**SUBJECT: Temporary Design Bulletin C02-08
Effective April 16, 2002**

This bulletin supersedes Temporary Design Bulletin C02-03.

FDOT NOISE WALL PILE/POST CONNECTION OPTIONS – GENERAL NOTES (Page 1 of 2)

FDOT NOISE WALL PILE/POST CONNECTION - OPTION NO. 2A (Page 2 of 2)

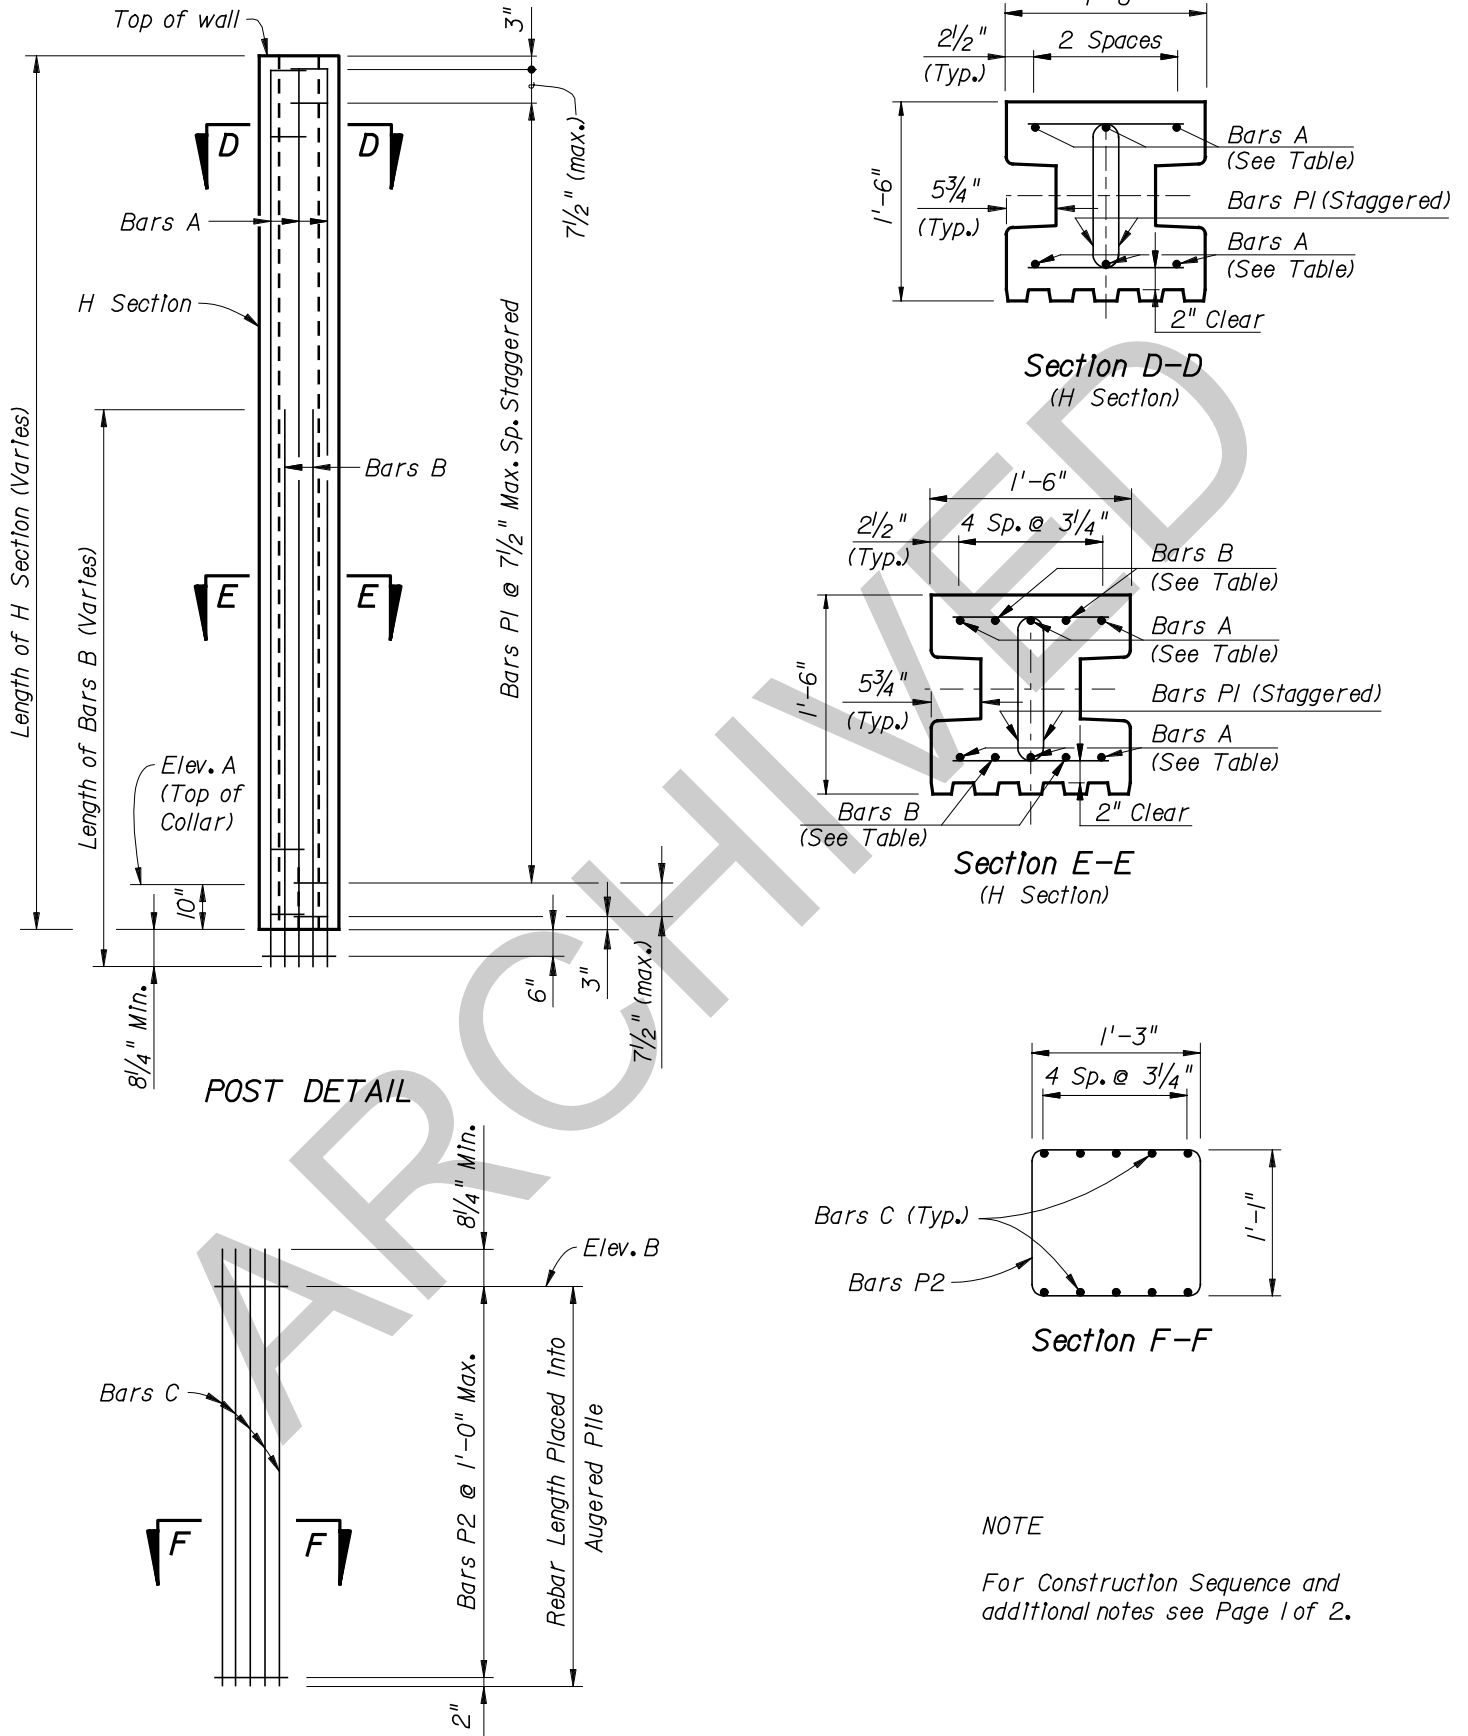
Requires cutting reinforcement Bars A and B in the post 8/4" minimum below the bottom of post. The cut-offs of Bars A and B shall be used as Bars C to form a cage using the P2 tie bars. The bar cage shall be lowered into the auger cast pile and carefully positioned to allow for coupling Bars C with Bars A and B, at the base of the post, with mechanical couplers.

FDOT NOISE WALL PILE/POST CONNECTION - OPTION NO. 2B (Page 1 of 3)

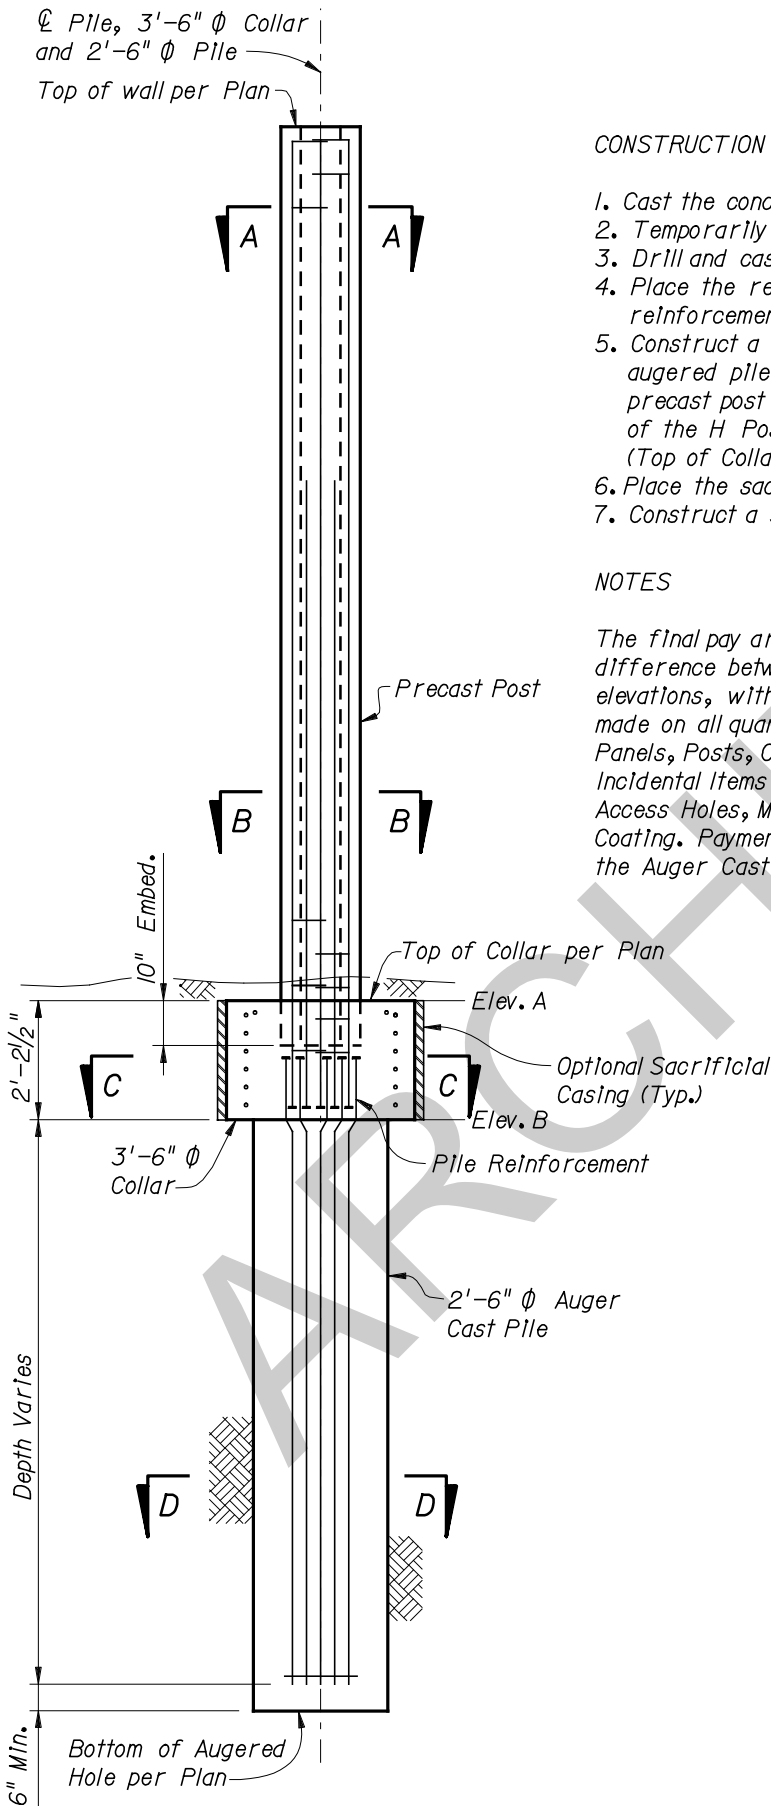
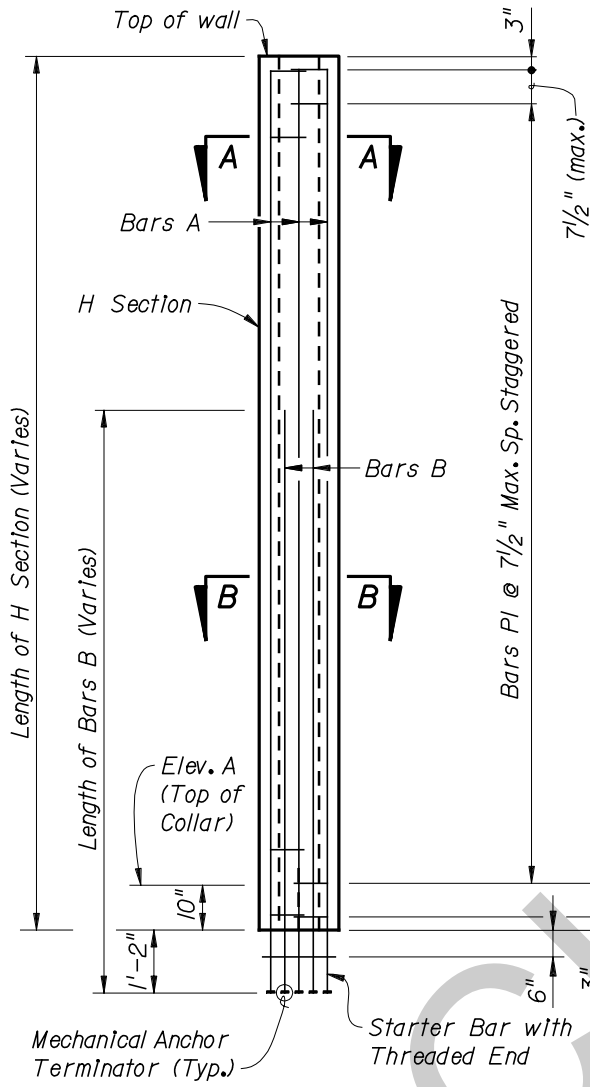
Option 2B

Requires cutting Reinforcement Bars A and B, in the post 1'-2" minimum below the bottom of post. The cut-offs of Bars A and B may be used as Bars C to form a cage using the P2 tie bars. Additional reinforcement Bars P2 shall be provided as shown in Augured Pile Reinforcement Detail on Page 2 of 2 of Option 2B, shown in the attached Appendix. Bars P2 shall be number 4 bars, 6'-1" long and bent to a 9/2" radius. If the pile cage is made from Bars A and B cut-offs, then the pile cage shall be raised to 1'-2" minimum above Elevation B. Otherwise Bars C shall be provided to lengths shown and shall be the same bar size as Bars A and B.

1. Cast the concrete H Post. See post detail on Page 2 of 2.
2. Temporarily excavate to Elev. B in the vicinity of the post.
3. Drill and cast a 2'-6" ϕ auger pile to Elev. B.
4. Place the rebar into the 2'-6" ϕ augered pile hole. See augered pile reinforcement Page 2 of 2.
5. Construct a template to properly align the precast post over the augered pile. Using mechanical anchor terminators connect the precast post rebar with the rebar in the augered pile. The bottom of the H Post section (see section A-A) shall be 10" below Elev. A (Top of Collar).
6. Place the sacrificial casing or collar form and collar reinforcement.
7. Construct a 3'-6" ϕ collar. Finish the concrete to Elev. A (Top of Collar).

FDOT NOISE WALL PILE/POST CONNECTION - OPTION NO. 2B (Page 2 of 3)

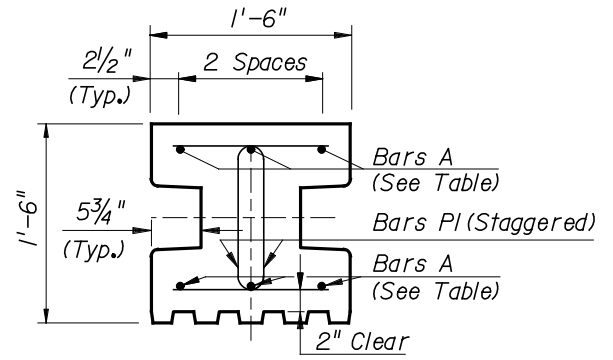
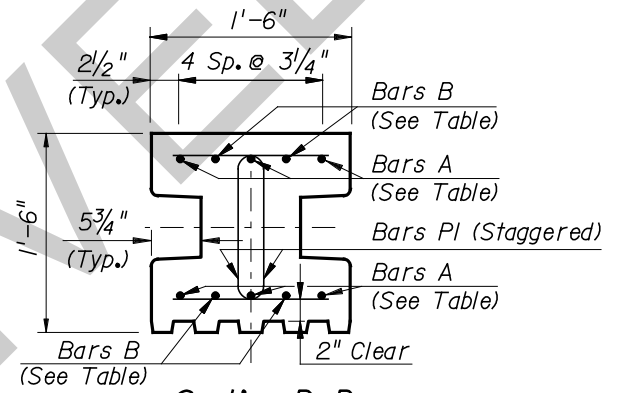
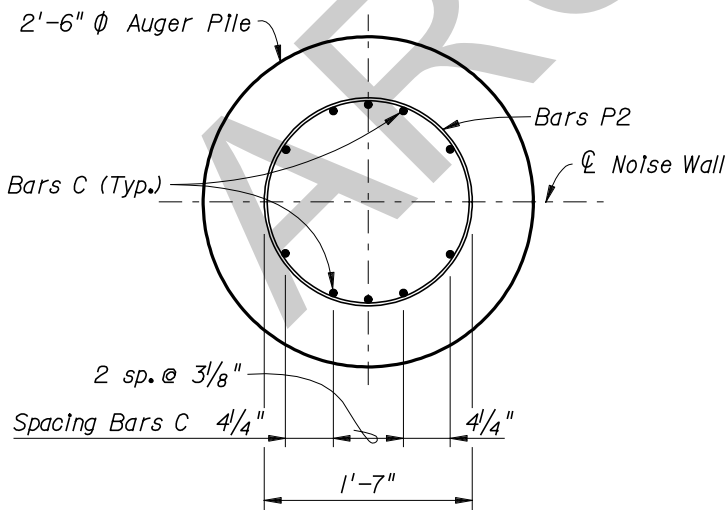
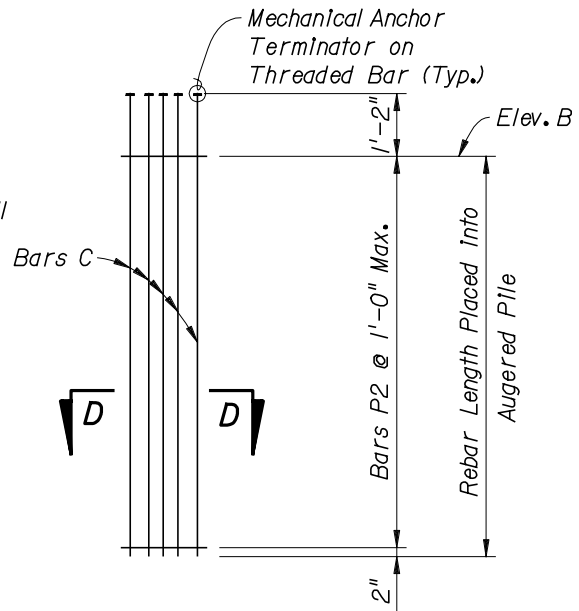
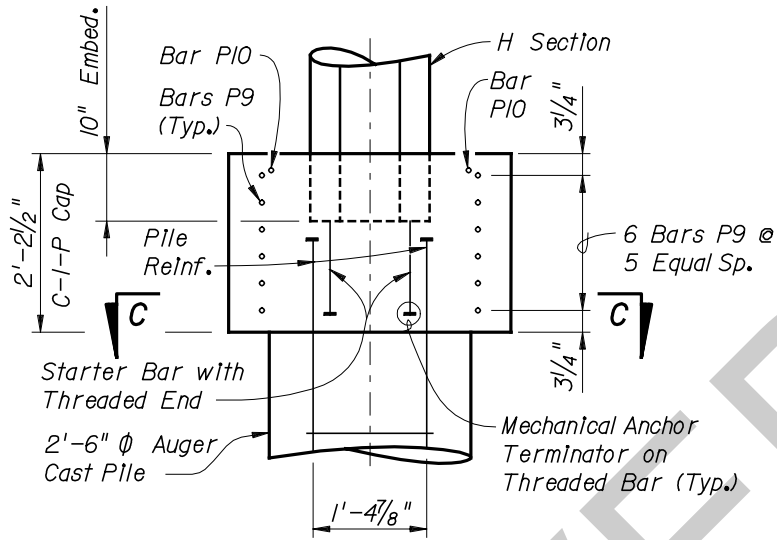
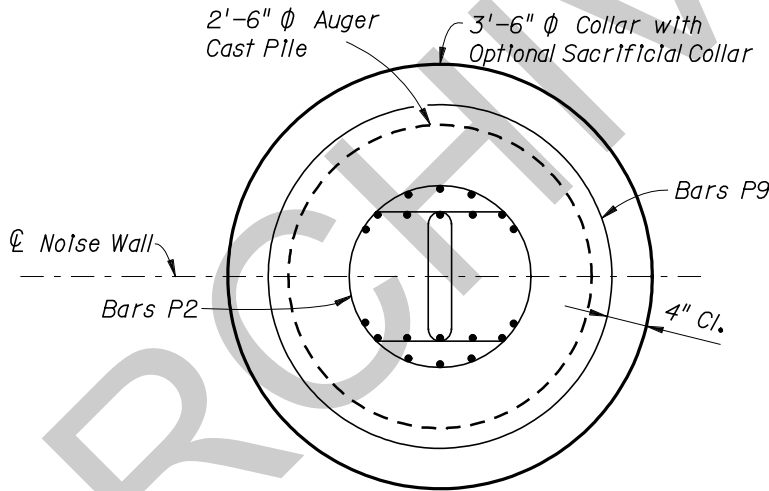
The top of all Bars C and the bottom of all Bars A and B shall be threaded and a mechanical anchor terminator installed in accordance with the manufacturer recommendation. The mechanical anchor terminator shall be submitted for approval.

FDOT NOISE WALL PILE/POST CONNECTION - OPTION NO. 3A (Page 1 of 2)

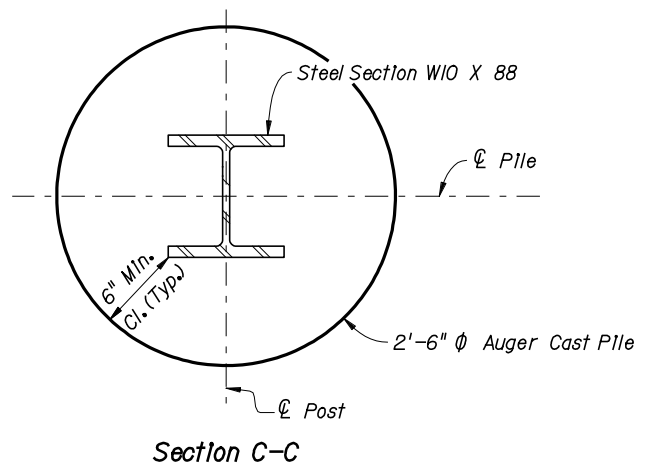
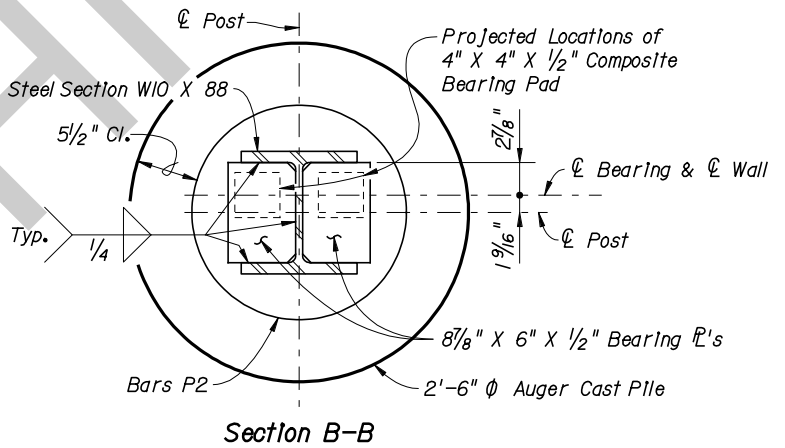
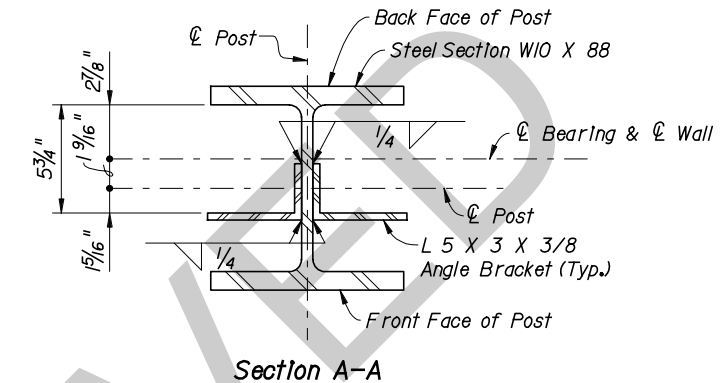
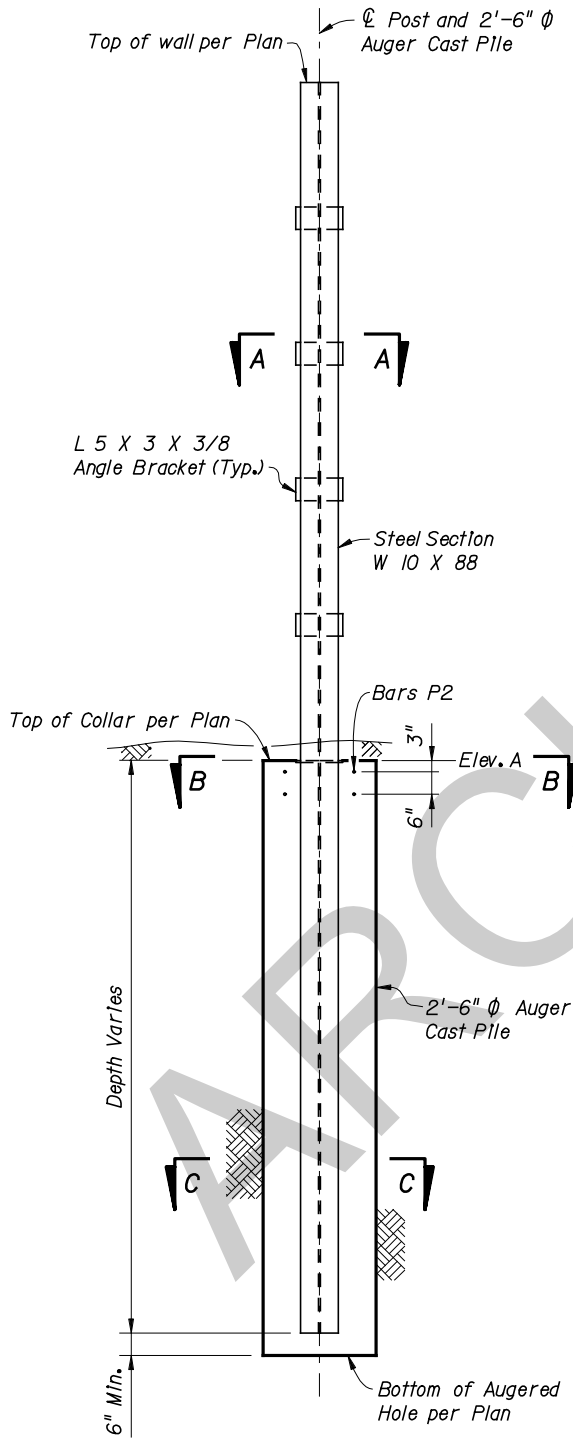
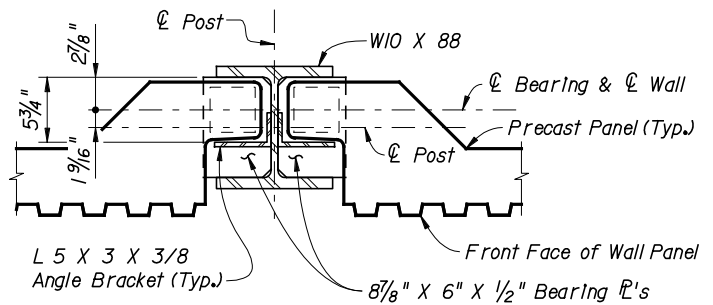
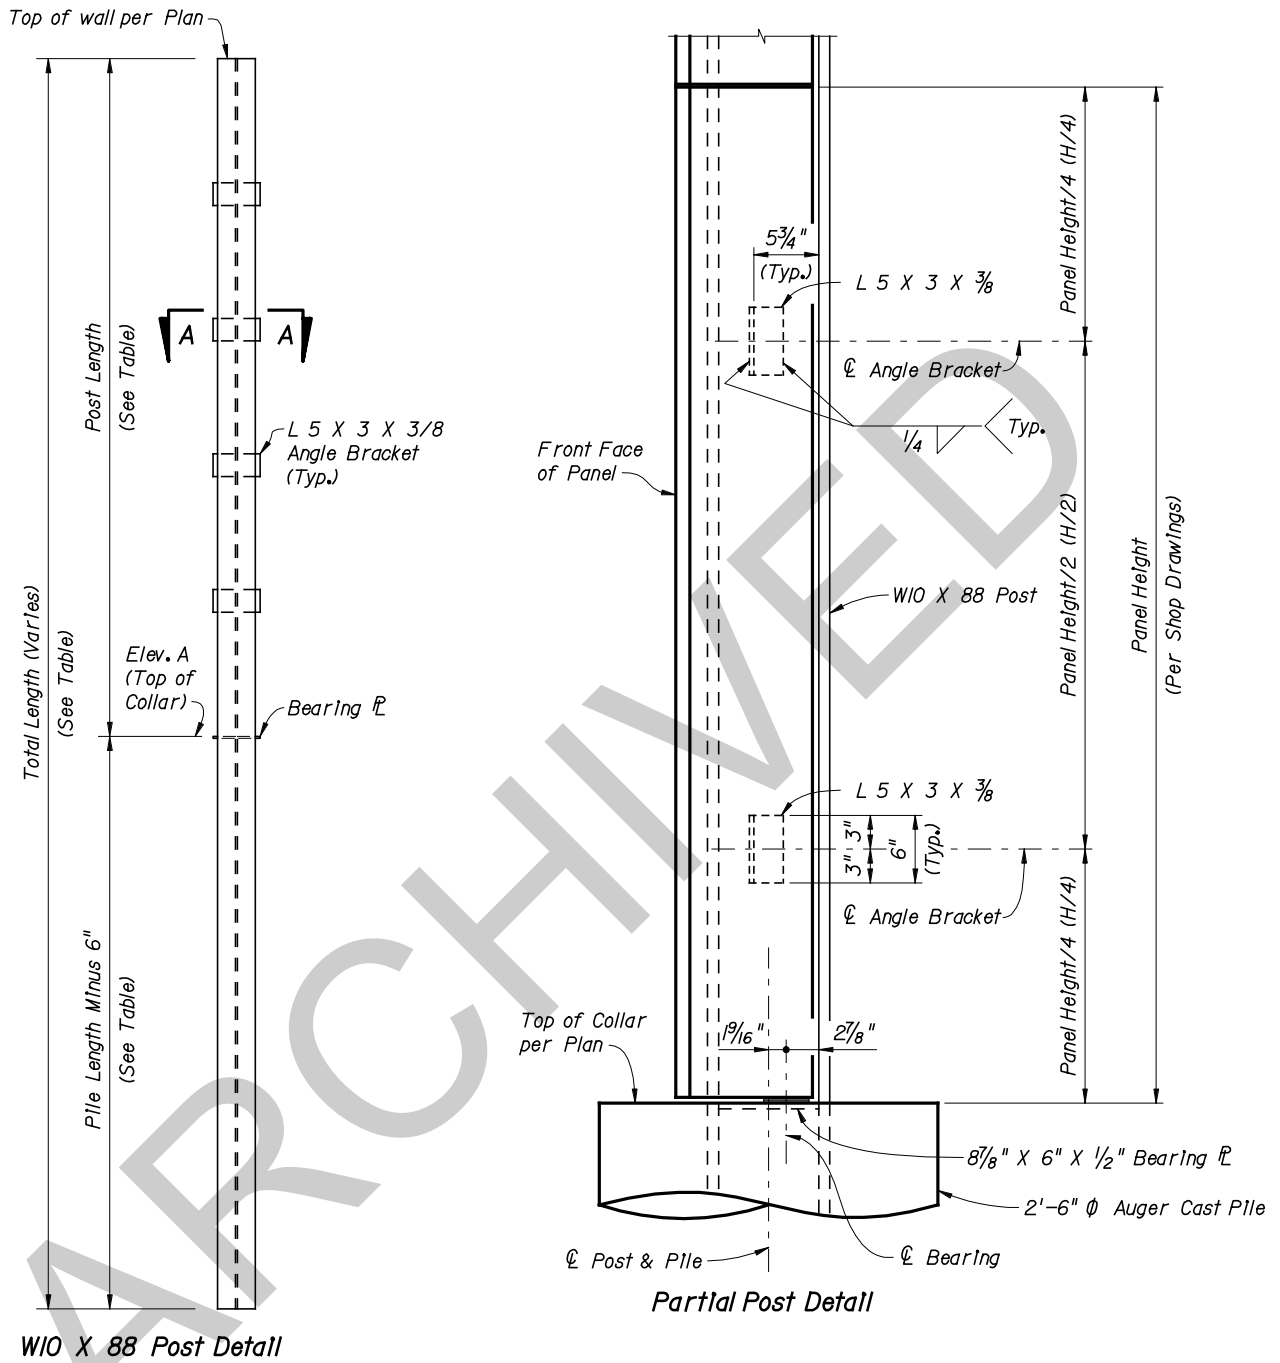
Option 3A

Replaces precast concrete post with structural steel post assembly. Deletes auger cast pile reinforcement except that two-P2 Bars shall be added at the top of the auger cast pile. The P2 bars shall be number 4 bars, 6'-1" long and bent to a 9½" radius.

The post assembly shall be shop fabricated and coated in the shop with a three-coat system comprised of one coat of an approved self-curing Inorganic zinc primer as described in Section 561 followed by two coats of coal tar epoxy. The limits of the coating system shall be the exposed surface area of the post assembly from the top of post to 2'-0" below Elevation "A". After the post assembly is installed, it shall be coated with an approved compatible Class 5 Applied Finish Coating or anti-graffiti coating in accordance with the plans and specification.

The length of the 19'-2" Panel is increased to 19'-10".

For this Pile/Post Connection Option the Wall Panel Length Increases 8" to 19'-10".
